Response letter for the review of: Numerical Analysis of High Pressure Cold Bend Pipe to Investigate

the Behaviour of Tension Side Fracture

Figure 9: Load-displacement response under bending load and internal pressure

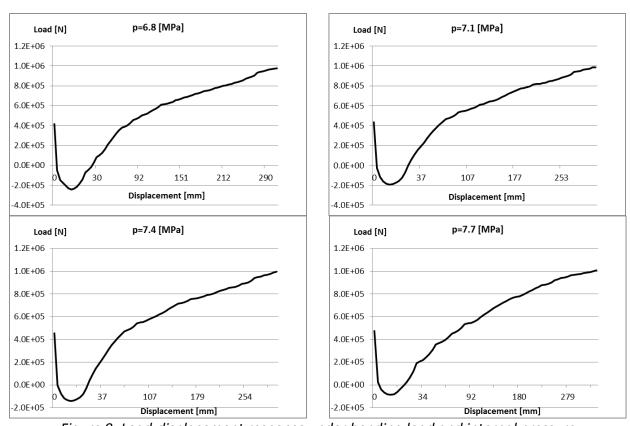
If you want to discuss the observation induced from a series of FEA results, you should show the comparison of the FEA results such as different internal pressures, pipe geometries, and so on.

We thank the reviewer for pointing out this missing part in the text. In order to compare the system response for different internal pressures, the load displacement curves showing the variation of the reaction force at the loading pin with respect to increasing displacement loading have been plotted for 4 different internal pressures. The load-displacement curves and their interpretations are incorporated in the "Results" section of the paper.

"It can be observed that there are minor differences between the load — displacement curves for the different internal pressure cases. The common feature of the 4 graphs is that the buckling in the compression side of the pipe takes place in the early stages of the applied bending load although there is no sharp transition to the post-buckling. These curves have been generated by plotting the variation of the reaction force at the loading pin with respect to the displacement of the loading pin in the positive x-direction. Since the increase in the pipe curvature is proportional to the applied displacement and since the model maximum moment is proportional to the reaction force in the x-direction, these curves also give an idea about the change of the maximum moment in the system with respect to the cold bend curvature. The graphs in Figure 9 show that the sign of the reaction force changes directly after the start of the displacement load step. This change of sign is related to the direction of the applied forces due to the internal

pressure and due to the external displacement loading. Since these two applied forces have opposite signs it follows that the greater forces caused by the internal pressure lead to negative values of the total reaction force at the beginning of the displacement load step. As the applied curvature increases the magnitude of the associated reaction forces exceeds the magnitude of the reaction forces associated with the internal pressure and the sign of the total reaction force becomes positive."
